Access Compliance Report Public Rights-of-Way (Curb Ramps)

Main Street: SOLSTICE_DR		Cross Street: COMET_TRAIL		Location:	W
ADA ID: RPAT211101103037	Ramp Type: Type 4 - Parallel	Initial Pass/Fail: Fail	Overall Compliance: No	Severity Score:	2
Codes/Mitigation Info/Possible Solution			Field Measurements/Component Compliance

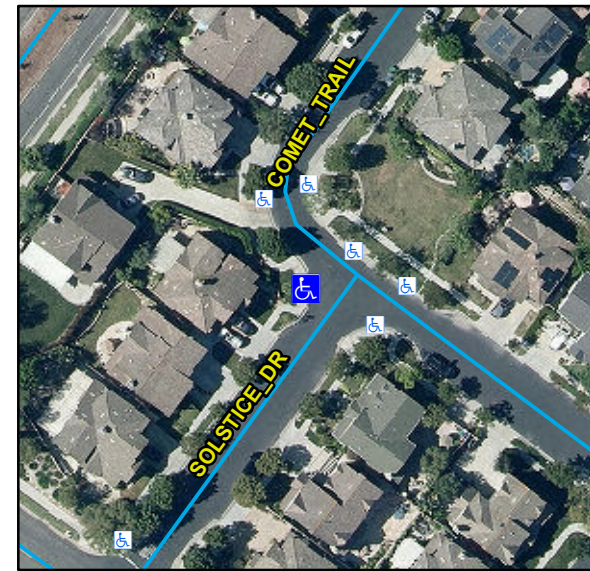
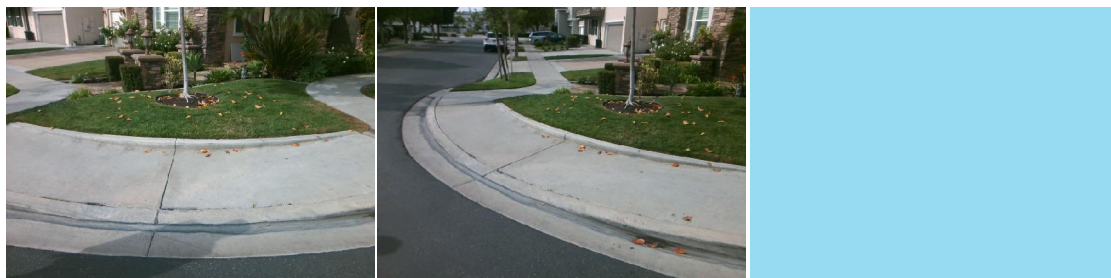
R304.2.2, R204.3, R304.5.3, STD 1115

Remove & Replace Curb Ramp With Two New Directional Ramps or Equivalent.
